Metro Inner Development Assessment Panel Agenda

**5.1 Lot 20 (No.141) Wellington Street, East Perth - Convenience Store
and Car Wash – DAP/22/02372**

State Administrative Tribunal Reconsideration – Responsible Authority Report (Regulation 12)

DAP Name:	Metro Inner DAP
Local Government Area:	City of Perth
Summary of Modifications:	• Redesign and relocation of the proposed control building to the northwest of the site • Relocation of the proposed drive through • Redesign and relocation of the proposed fuel bowser canopy • Relocation of the proposed car wash and vacuum area • Consolidation of proposed crossovers • Landscaping and screening additions • Submission of updated technical reports to support the proposed development
Applicant:	Nik Hidding, Hidding Urban Planning
Owner:	Perth OHP Pty Ltd
Value of Development:	\$3 million
Responsible Authority:	City of Perth
Authorising Officer:	Julia Kingsbury, Alliance Manager Development Approvals
LG Reference:	DAP-2022/5331
DAP File No:	DAP/22/02372
SAT File No (DR reference):	DR 044
Date of Decision under Review:	29 February 2024
Application for Review Lodgement Date:	4 April 2024
Attachment(s):	1. Location Plan 2. Perspectives 3. Deve

PLANNING APPLICATION

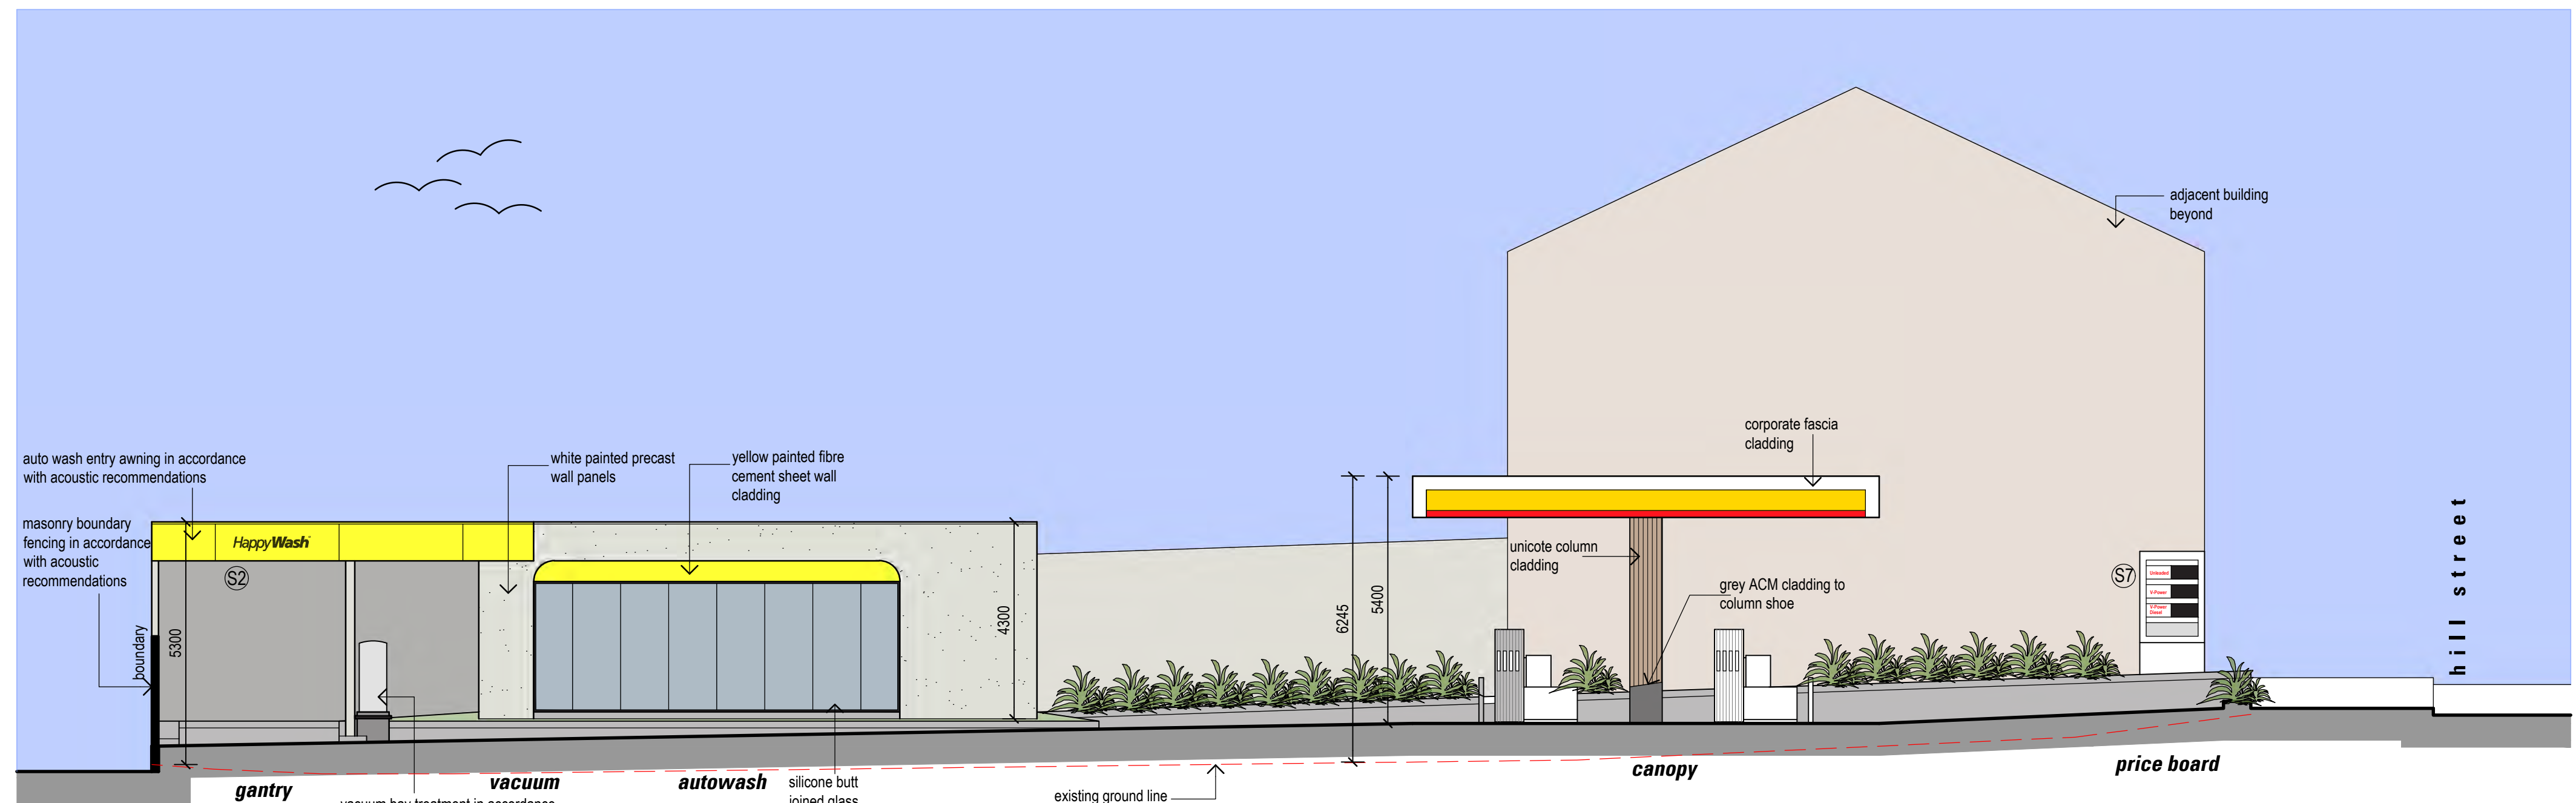
The revised proposal relocates the drive through facility to enable the control building to be sited in the north-west corner of the site, where the design has been significantly modified to provide a shopfront including an entry and small outdoor dining area along Wellington Street.

The main building is compliant with the building height, setback and plot ratio requirements of CPS2 and the Goderich Design Policy. The revised siting of the building in the northwest corner of the site is a positive design outcome as it is more consistent with the setback of development in the locality and provides for a more legible and convenient entry for pedestrians accessing the development from the footpath. This design modification also increases opportunities for surveillance with the windows of the main building close to the street. It is also more consistent with the general built form of the locality, which predominantly features buildings with a nil to street boundaries. In this way, the siting more appropriately responds to the 'Context and character', 'Built form and scale', 'Eligibility' and 'Safety' principles of SPP 7.0.

The screen wall proposed in front of the drive through area will assist to screen vehicles from view of Wellington Street. The finishes of the screen are however light on detail; it is important that the finishes are high quality given the scale and prominence of the screen. It would also be ideal if the screen could incorporate features with high amenity such as vertical landscaping or art. For these reasons, a condition that requires final details of the screen to be submitted to the City for approval would be appropriate.

ROOF PLAN
1:200 AT A1
total potential PV cell capacity across all rooftops - 49kW

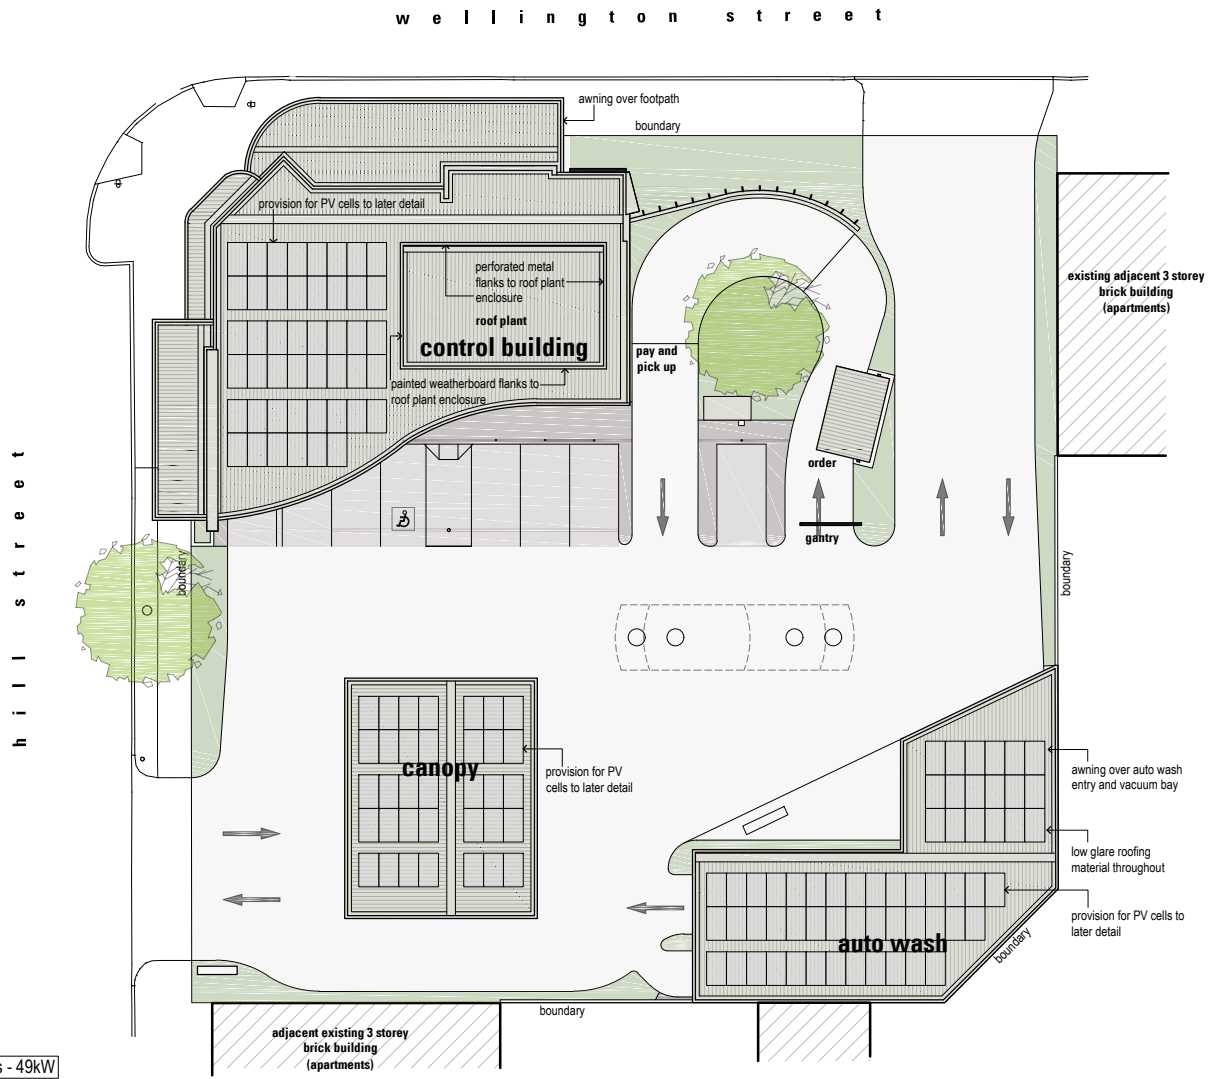
In response to the Design Review Panel's comments, the applicant submitted an Environmentally Sustainable Design Measures Plan. The Plan details the proposed ESD measures that will be implemented on-site, including solar panels on the rooftop of the control building and the ability of the car wash to recycle wash water. There will be an electric charger available on-site, with the ability to add more as the demand
